<input checked="" type="checkbox"/> ECO <input type="checkbox"/> ECR	NO. 5007	EFF DATE OF CHG 21 Feb 97	REQUESTED BY ECR 1016	PREMIER	PAGE 1 OF 2
REASON FOR CHANGE INCORRECT HDWR CALL OUT		DOCUMENTS AFFECTED B67-43001 B67-43001PL	SYSTEM BLADE FOLD KIT	MATL DISPOSITION	
MARKED PRINTS ATTACHED YES <input type="checkbox"/> NO <input type="checkbox"/>			SERIAL NO EFF	REWORK	STORE <input type="checkbox"/> IN MFG. <input type="checkbox"/>
				SCRAP	
				USE AS IS	<input checked="" type="checkbox"/> <input checked="" type="checkbox"/>

DESCRIPTIONB67-43001, SHEET 1

PREMIER
AVIATION, INC

B67-43001, SHEET 3

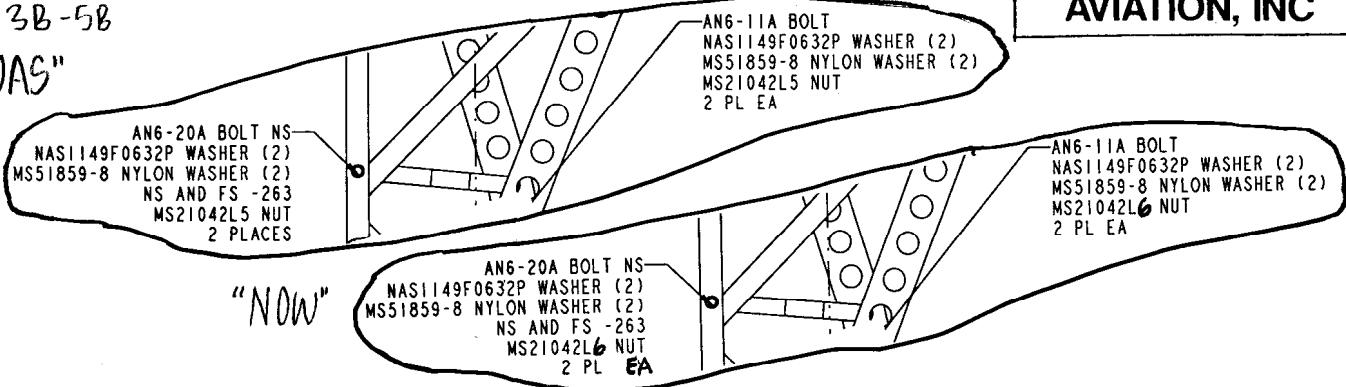
ZN 3B-5B

"WAS"

B67-43001, SHEET 4

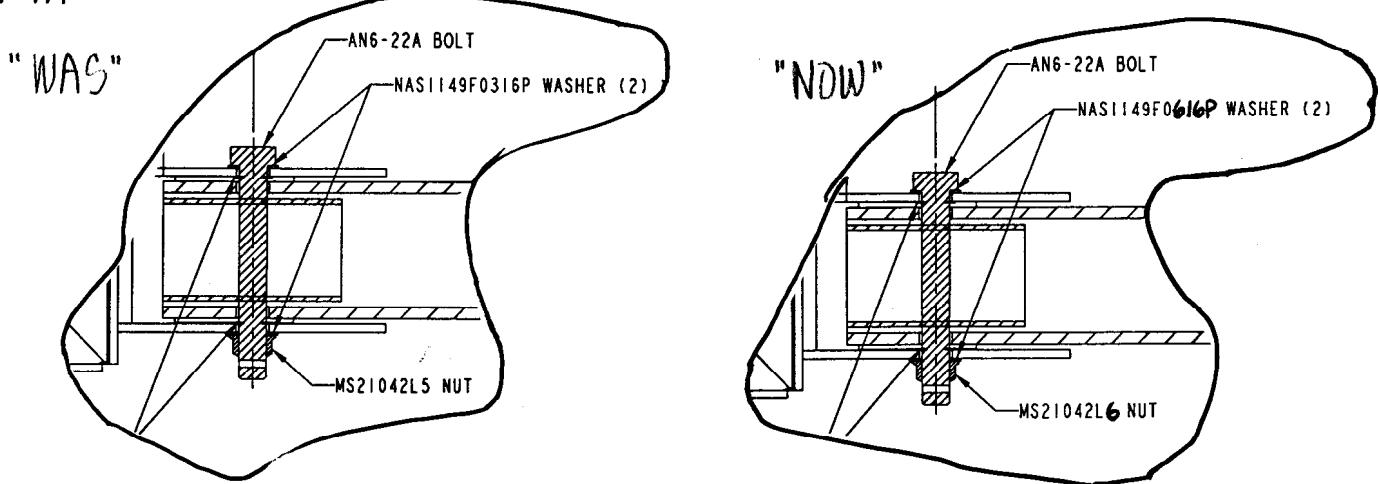
ZN 7A

B67-43001, SHEET 9

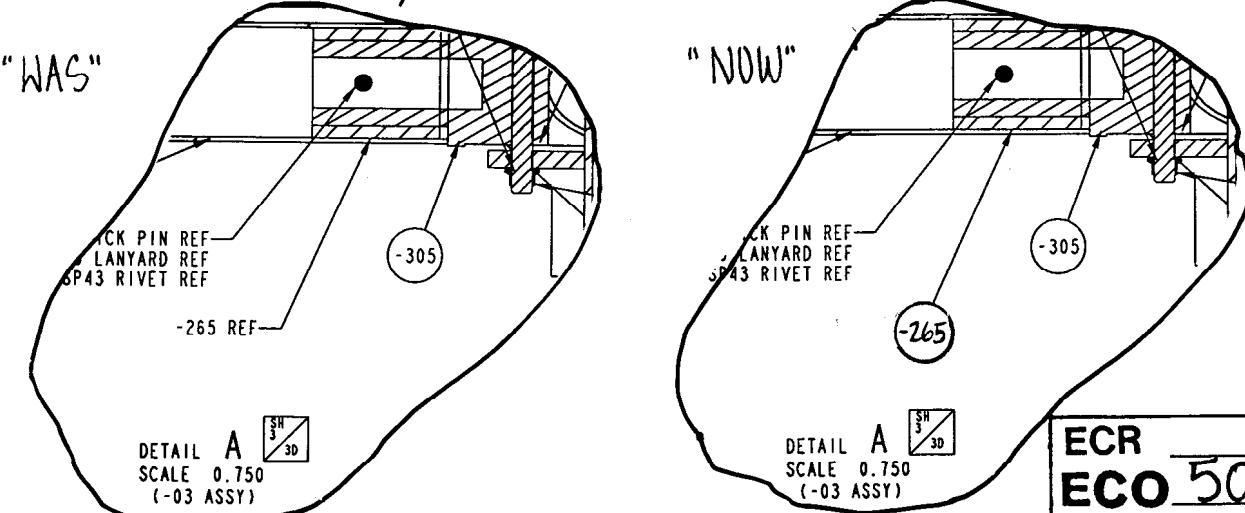
CHANGE DETAIL "A" AS SHOWN, ZN 7A:
